APPARATUS AFFECTED: DATASPEED 40/4 Device Cluster Controllers (DCC). -402 Series.

PARTS AFFECTED: TP410509 Circuit Card
TP410510 Circuit Card
TP410511 Circuit Card

REASON: To improve program tab routine and to return keyboard display (KD) to local mode after an unsolicited select.

TABLE A — Circuit Card TP410509

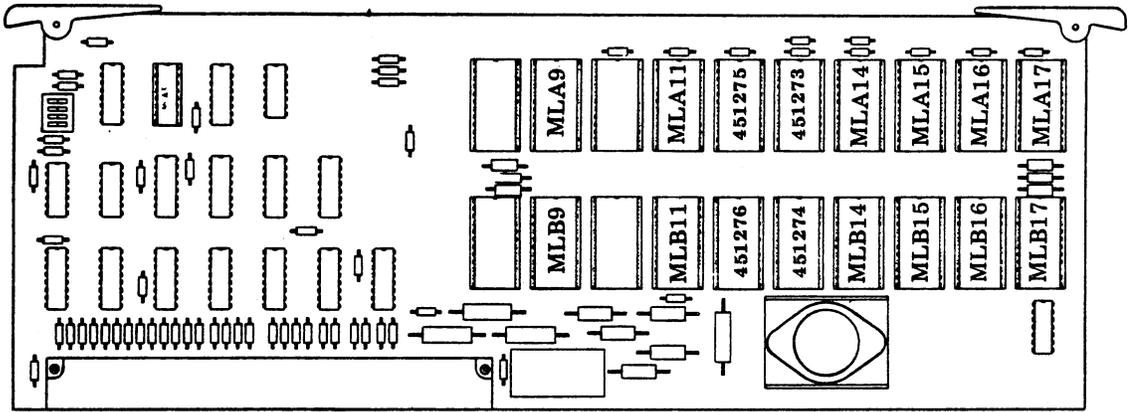
CHANGE: Refer to Tables A, B and C for EPROM changes.

<u>REMOVE</u>	<u>POSITION</u>	<u>INSTALL</u>
451048	MLA 13	451273
451049	MLB 13	451274
451050-2	MLA 12	451275
451051-2	MLB 12	451276

Change issue of card from 3A to 4A

TABLE B — Circuit Card TP410510

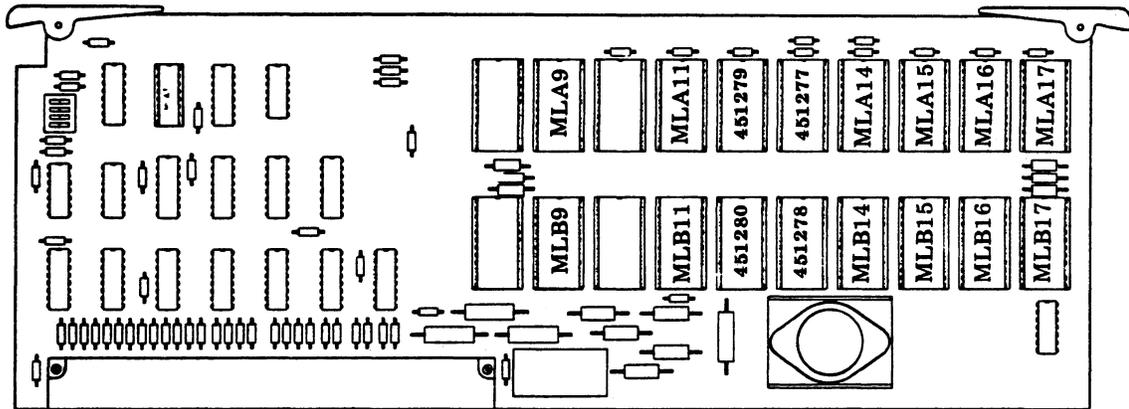
<u>REMOVE</u>	<u>POSITION</u>	<u>INSTALL</u>
451060	MLA 13	451277
451061	MLB 13	451278
451062-2	MLA 12	451279
451063-2	MLB 12	451280

Change issue of card from 3A to 4A

TABLE C — Circuit Card TP410511

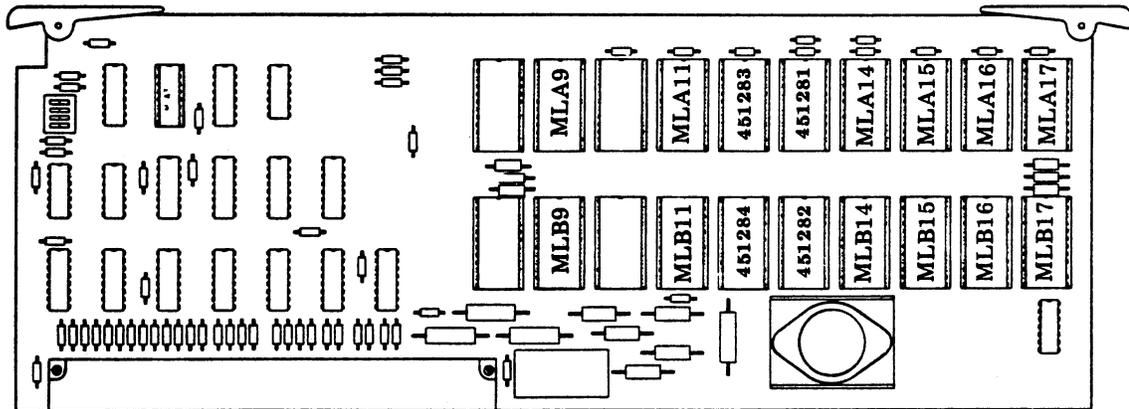
<u>REMOVE</u>	<u>POSITION</u>	<u>INSTALL</u>
451074	MLA 13	451281
451075	MLB 13	451282
451076-2	MLA 12	451283
451077-2	MLB 12	451284

Change issue of card from 3A to 4A
